INSTALLATION MANUAL

REF NO.	BT02066
DATE	Oct. 31, 2002

SUBJECT: INTRODUCTION OF REINFORCED TYPE MOUNTING BRACKET OF A/C COMPRESSOR ON WA1200-3

PURPOSE: To introduce modification procedure to reinforce the air compressor mounting bracket of the air conditioning system on WA1200-3 wheel loaders to prevent occurrence of cracks

Air compressor mounting bracket (Part No. 42C-07-11161) of the air conditioning system:

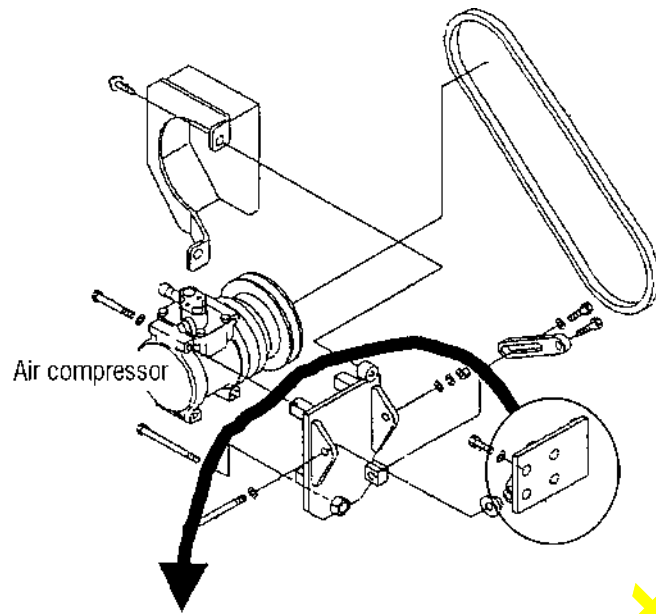
There is a possibility of occurrence in the welded section between the pipe and plate.

welded section between the pipe and the plate

- ① When modifying the bracket locally, make the modification as per the modification procedure being indicated on pages 3 and 4.
- ② When ordering the improved bracket (42C-07-11162) to replace the current bracket, it is not necessary to make the modification as per pages 3 and 4.

Weld the reinforcement plate to the hatched section additionally.

New part number: Same as the current Part No. 42C-07-11162

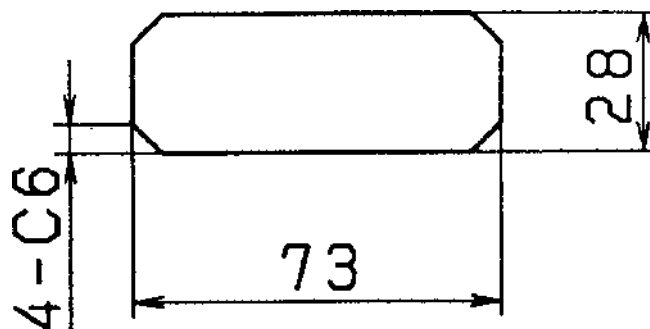
Make the reinforcement plate as per the drawing shown below.

Plate thickness: t 6
Material: SS400

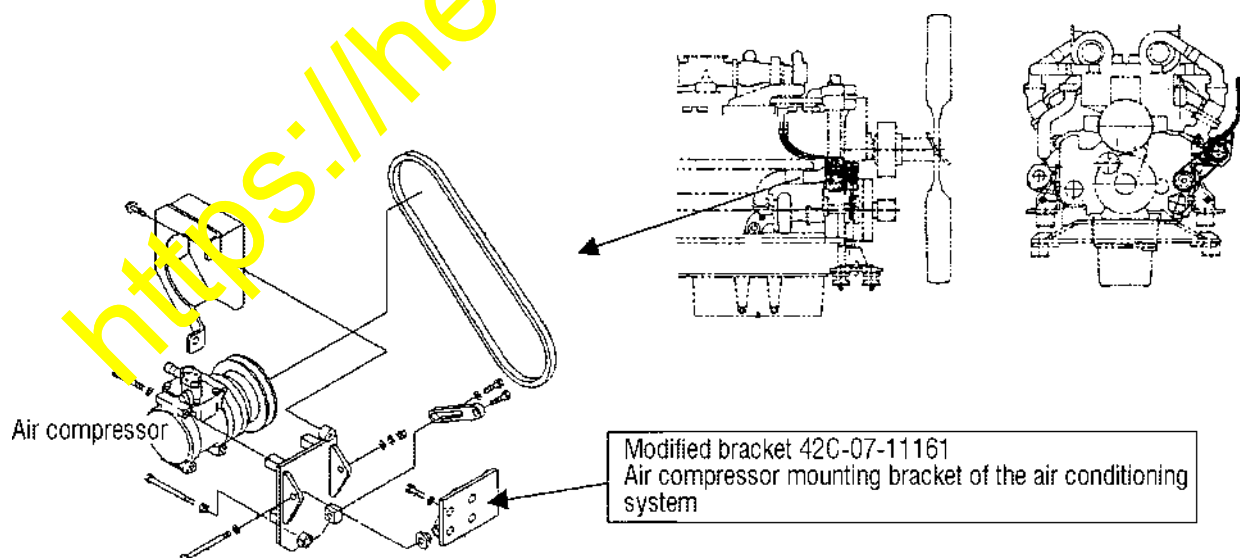
Remove the air compressor mounting bracket (42C-07-11161) of the air conditioning system from the engine.

When removing the air compressor of the air conditioning system from the engine, leave the air conditioner hose being connected to the air compressor and remove them together.

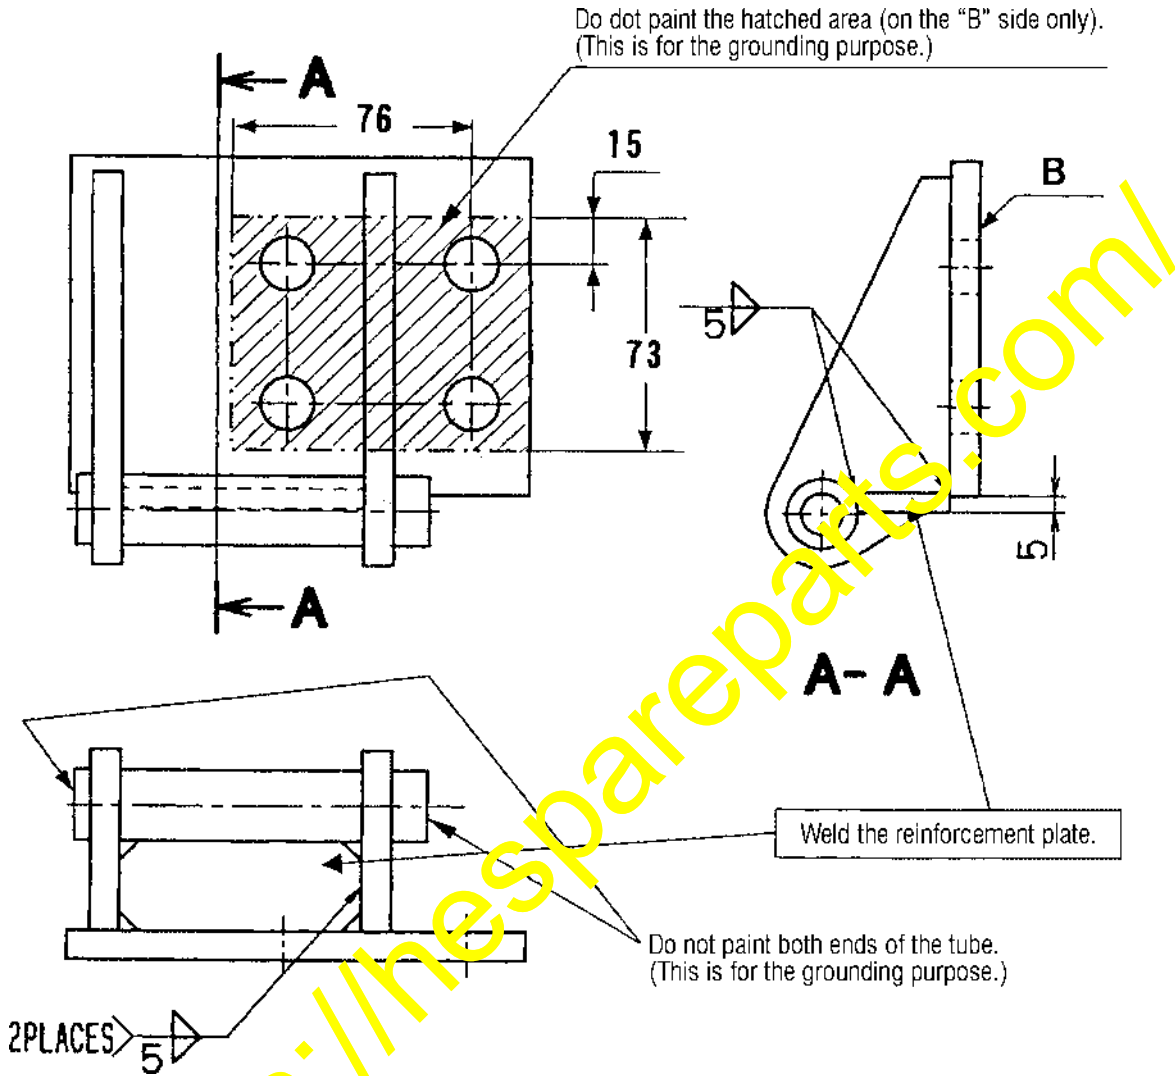
Weld the plate which has been made out as per the instructions given in the above Section (1) onto the bracket which has been removed as per the instructions given in the above Section (2).

After finishing the welding work, paint the modified surfaces.
However, do not paint the areas instructed not to paint in the above drawings.

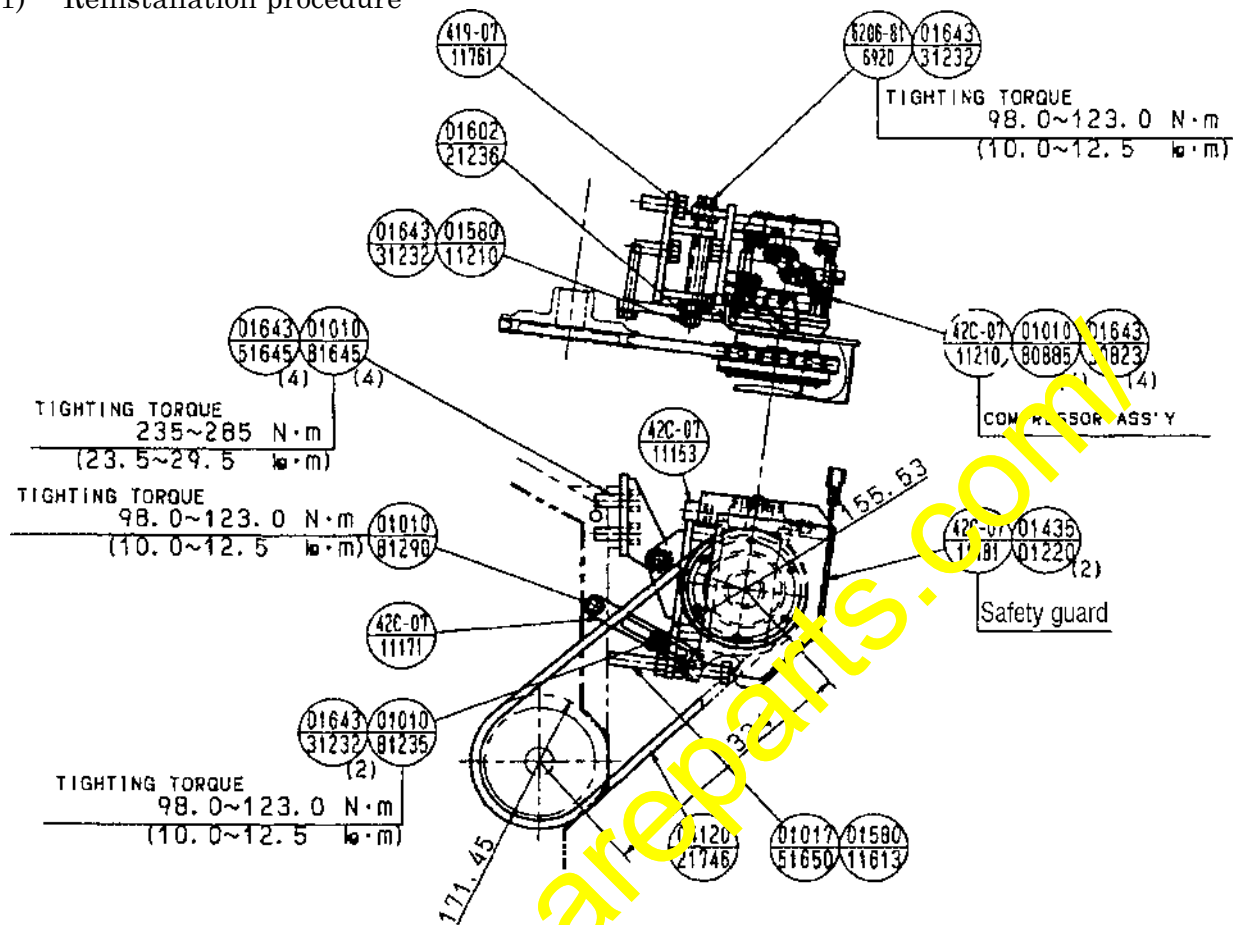
1) Reinstallation procedure

When carrying out the above reinstallation work, pay attention to the alignment error of the belt. Make the reinstallation work maintaining the alignment error (the dimension "a" in Fig. 2 below) of the belt within 2 mm.

- 2) After finishing the reinstallation work, adjust the belt tension as per the procedure given in Fig. 1. below.

Fig. 1

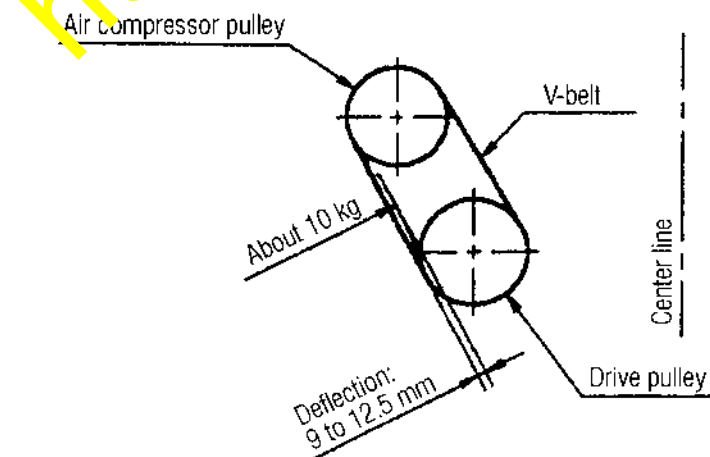
Belt tension adjustment procedure

Adjust the belt tension so that a deflection of 9 to 12.5 mm occurs when the center point between the air compressor pulley and the drive pulley on the V-belt is depressed by the ball of the thumb (with a force of about 10 kg).
